# Access Compliance Report

## Public Rights-of-Way

Intersection ID: 10025976	Main Street: ELM_LN	Cross Street: N/A	Location: SW
ADA ID: 1EB4E1B6C420	Ramp Type: Directional1	Initial Pass/Fail: Fail	Overall Compliance: No
		Severity Score: 1.25

#### Codes/Mitigation Info/Possible Solution

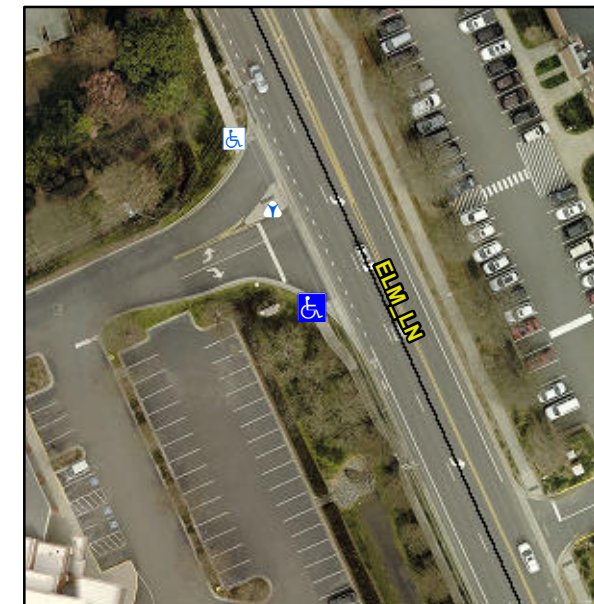
**R304.5.3**

Compliance	Description	Data	Compliance	Description	Data
N/A	Ramp Length (in)	84.0	N/A	Grade Break?	N/A
Yes	Ramp Width (in)	69.5	N/A	Grade Break Slope (%)	0.0
Yes	Ramp Slope (%)	3.7	N/A	Grade Break XSlope (%)	0.0
No	Ramp XSlope (%)	4.6			
N/A	Flare Type LT	N/A	N/A	Flare Type RT	N/A
N/A	Flare Slope LT (%)	N/A	N/A	Flare Slope RT (%)	0.0
N/A	Flare Traversable LT?	N/A	N/A	Flare Traversable RT?	N/A
N/A	Landing Length (in)	0.0	N/A	DWS Provided?	N/A
N/A	Landing Width (in)	0.0	N/A	DWS Contrast?	N/A
N/A	Landing Slope (%)	0.0	N/A	DWS Length (in)	N/A
N/A	Landing X Slope (%)	0.0	N/A	DWS Full Width?	N/A
N/A	Landing Curb? (Y/N)	N/A	N/A	DWS Offset LT (in)	N/A
N/A	Shared Landing?	N/A	N/A	DWS Offset RT (in)	N/A
N/A	Gutter Ponding?	0.0	N/A	Gutter Slope (%)	N/A
N/A	Gutter Lip Ht (in)	0.0	N/A	Gutter X Slope (%)	N/A
N/A	Painted X Walk1?	No		Road Slope (%)	3.7
	X Walk 1 Direction	To N		Road X Slope (%)	7.1
	X Walk 1 Width (in)	N/A		Clear Space?	N/A

**Remove & Replace Entire Ramp.**
